Sundry Print Report

Well Name: POKER LAKE UNIT

Type of Action: Plug and Abandonment

PLUG AND ABANDON WELLBORE
POKER LAKE UNIT 083
EDDY COUNTY, NEW MEXICO
Class I

Poker Lake Unit 083 - Proposed WBD

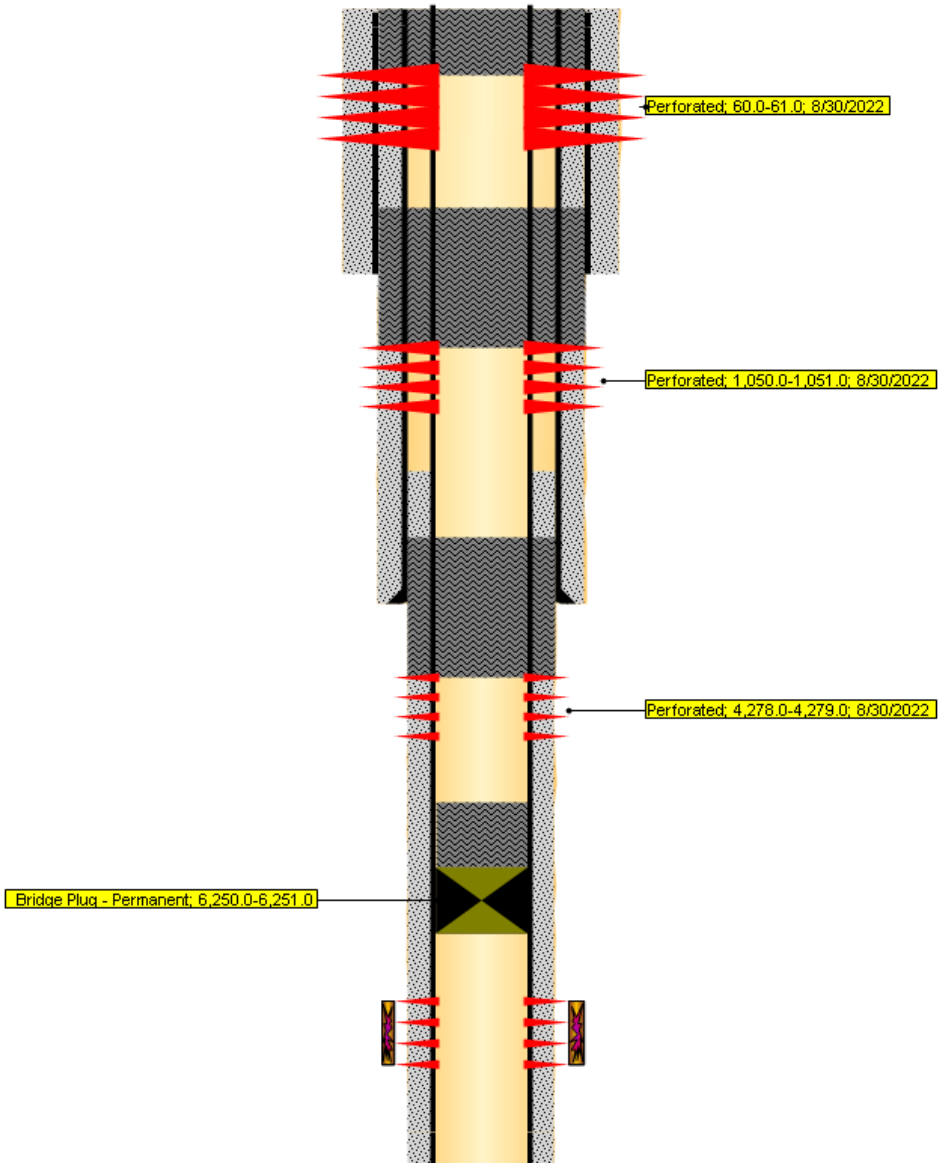
Perf and squeeze 60’ to surface.

Perf and squeeze 175 SKS Class C: 1050’ – 743’.

Perf and squeeze 54 SKS Class C: 4278’ – 4050’.

Spot 25 SKS Class C atop CIBP: 6250’ – 6215’. Pressure test CIBP to 500 psig for 30 min.

6) ~~Perforate at 4278'.~~ **Tag and verify all plugs excluding CIBP plug and surface**

7) RIH 2-7/8" tubing and ~~squeeze~~ **SPOT** 54 SKS Class C cement from 4278' to **3946**'
(T/Delaware, 8-5/8" CSG shoe, **BOS**).

10) MIRU WLU, perforate at **100'**.

Poker Lake Unit 083 - Proposed WBD

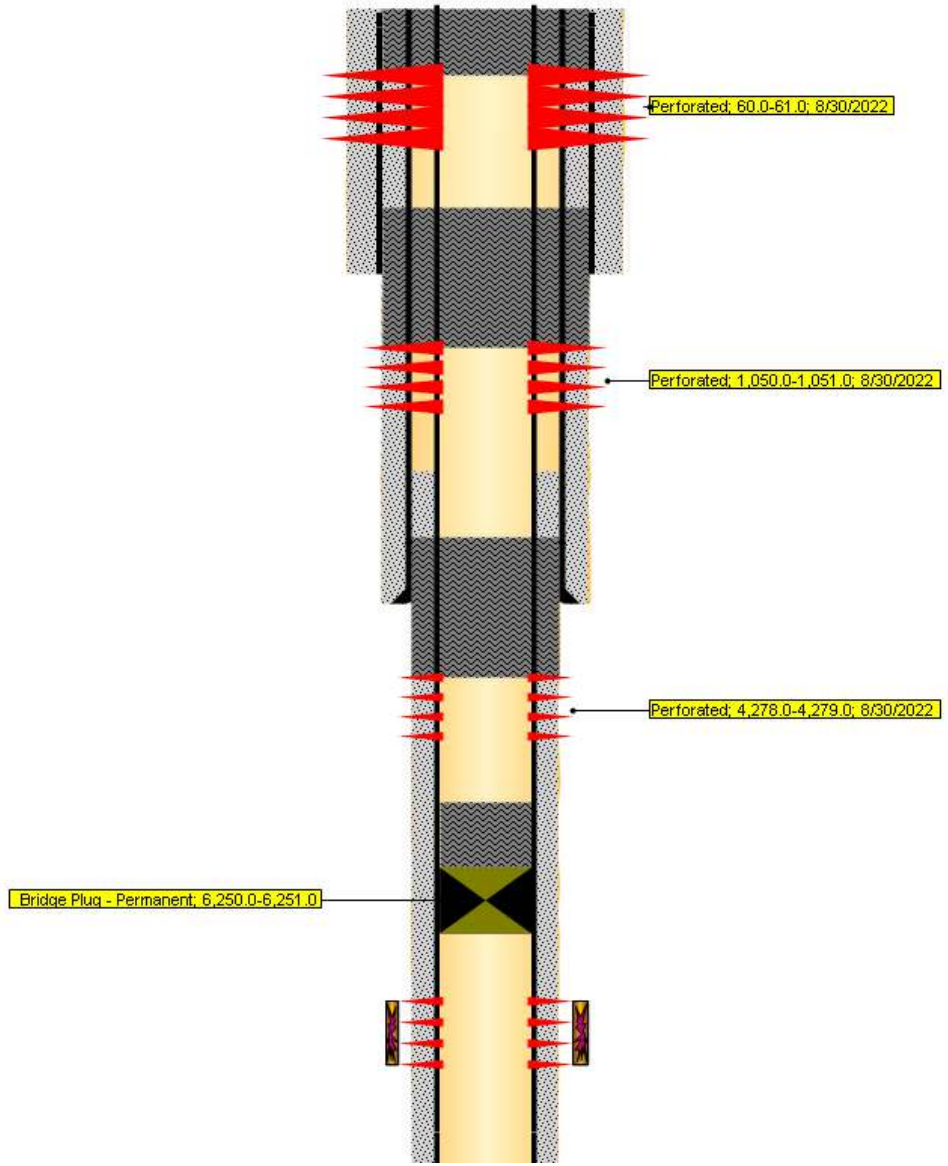
Tag and verify all plugs excluding CIBP plug and surface

Perf and squeeze **100'** to surface.

SPOT(TOC: 3360') 54 SKS Class C: 4278' – **3946'(Including BOS)**.
